## Appendix D

### Comment Forms and Roll Plan Comments Received at Angus Glen Community Centre

## Kennedy Road Class Environmental Assessment Study

Steeles Avenue to Major Mackenzie Drive

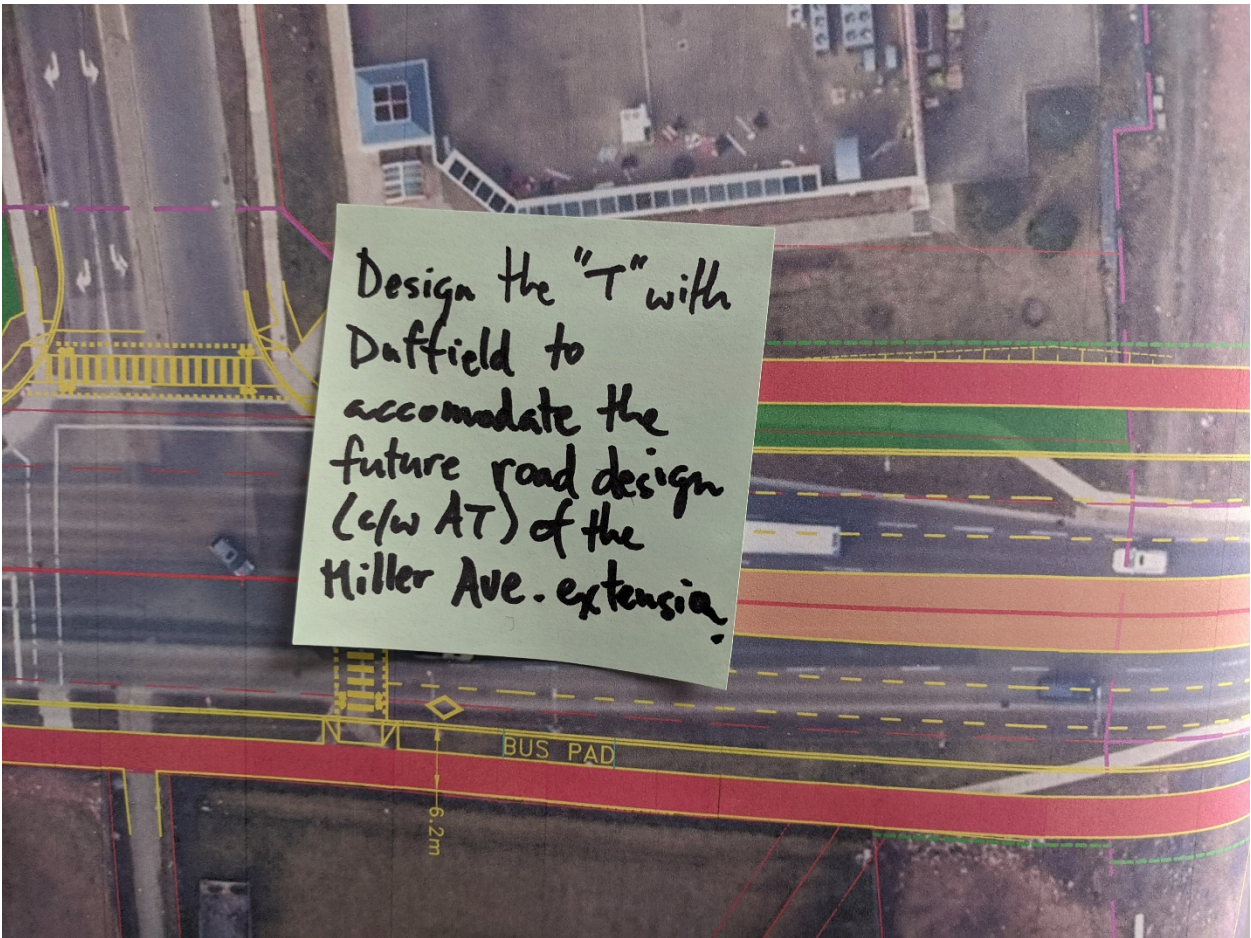
Design the "T" with  
Duffield to  
accommodate the  
future road design  
(c/w AT) of the  
Miller Ave. extension.

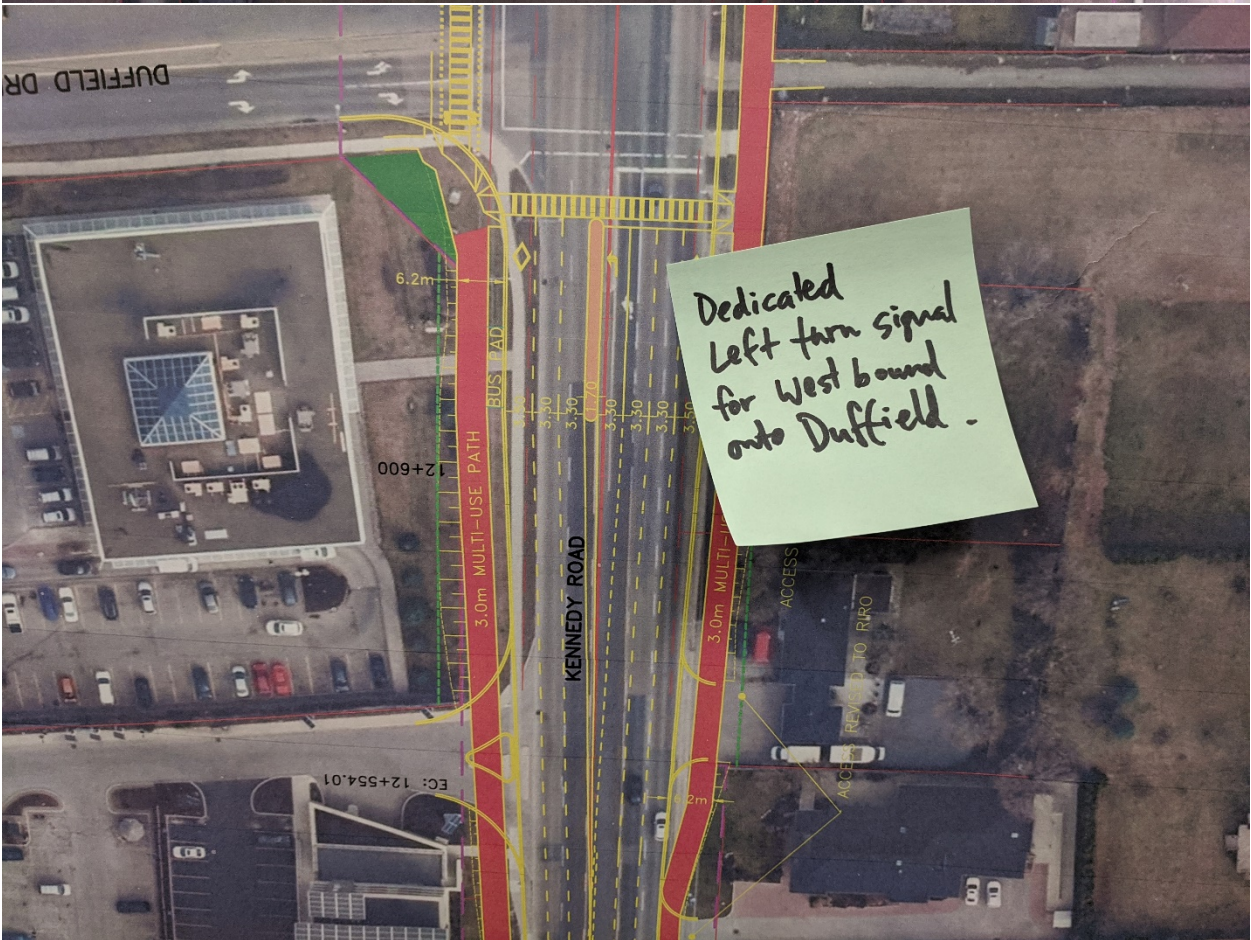
Dedicated  
Left turn signal  
for West bound  
onto Duffield.
